Access Compliance Report Public Rights-of-Way (Curb Ramps)

| Intersection ID: 10037598 | Main Street: SENECA_PL | Cross Street: N/A | Location: NW |
| ADA ID: 08DC3023A8ED | Ramp Type: ParaDiag | Initial Pass/Fail: Fail | Overall Compliance: No |

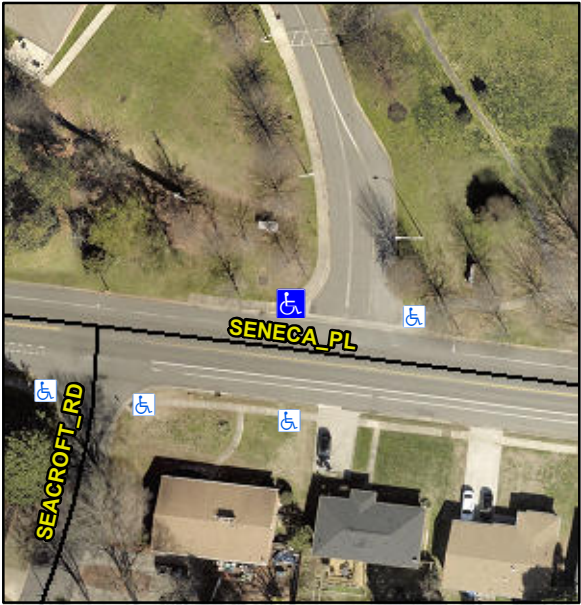
Surveyor Notes:
LT RP < 5%

PROW/ADA:
R304.3.2

| Compliance | Description | Data | Compliance | Description | Data |
|------------|----------------------|------|------------|-----------------------------|------|
| Yes | Ramp Slope LT (%) | 4.6 | No | Ramp Slope RT (%) | 13.9 |

Possible Solutions:
Remove & Replace Curb Ramp With Two New Directional Ramps or Equivalent.
